Serial No. : 10/604,561
Applicants : Gerald L. Dykstra et al.
Response to Office Action : Mailed From USPTO on 09/09/2005
Page : 7

REMARKS

Appl. No. 10/604,561
Response Dated Jan. 6, 2006
Reply to Office Action Mailed Sept. 9, 2005
Annotated Sheet Showing Changes

AppL No. 10/604,561
Response Dated Jan. 6, 2006
Reply to Office Action Mailed Sept. 9, 2005
Annotated Sheet Showing Changes

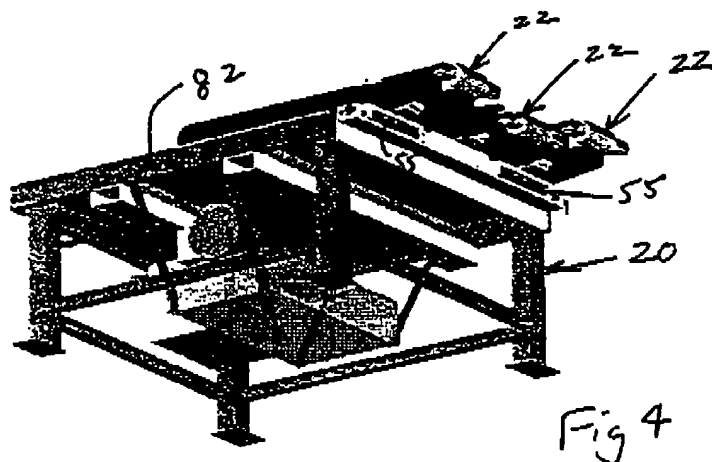
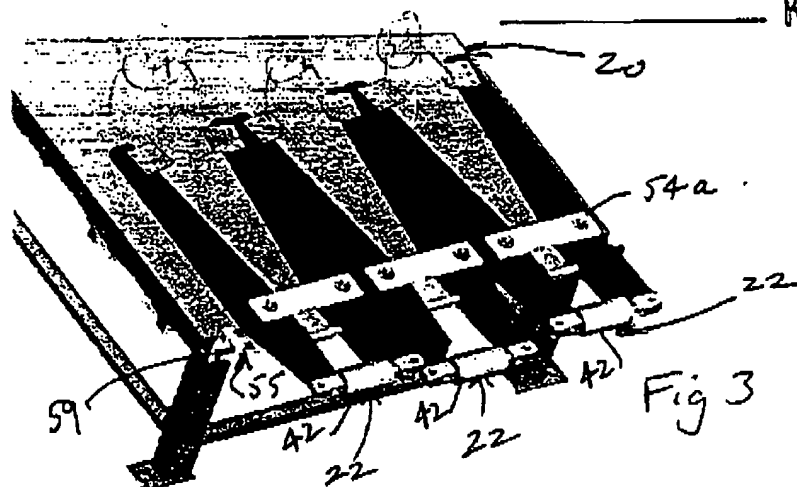
Reference No. 34 added

Fig 5

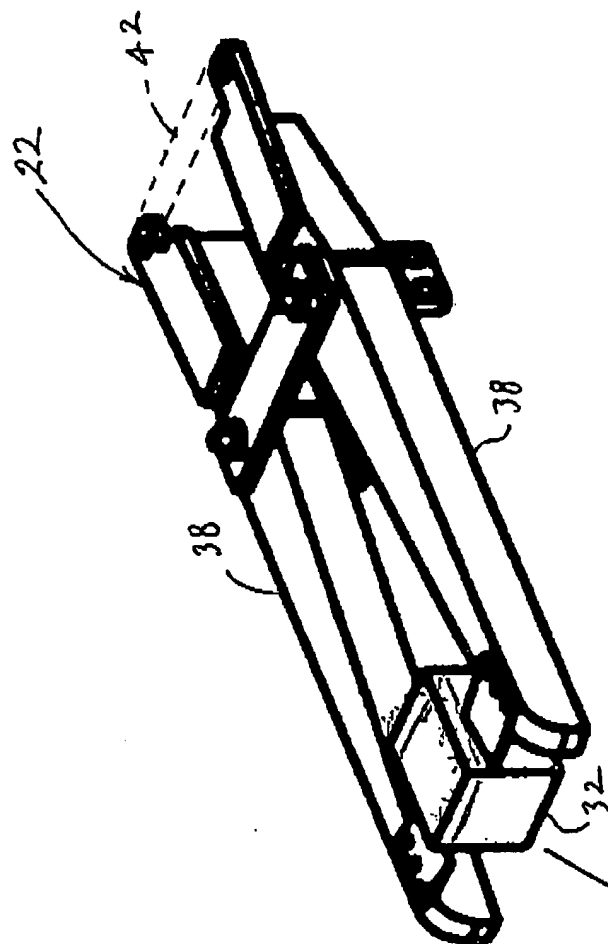
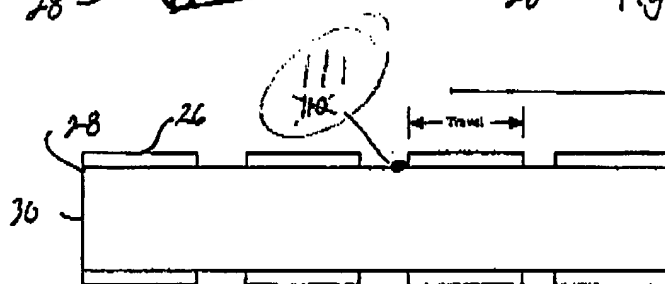
Position of blades 34
raised with respect
to block 32

Appl. No. 10/604,561
Response Dated Jan. 6, 2006
Reply to Office Action Mailed Sept. 9, 2005
Annotated Sheet Showing Changes

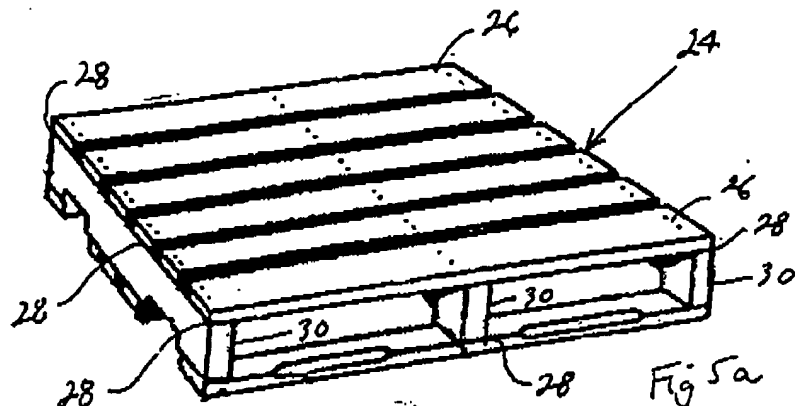
The disclosure is objected to because "diamond wire 110" uses a part number already in use. Paragraph [0031] is amended to change the part number to "111".

Reference No. 110
changed to 111
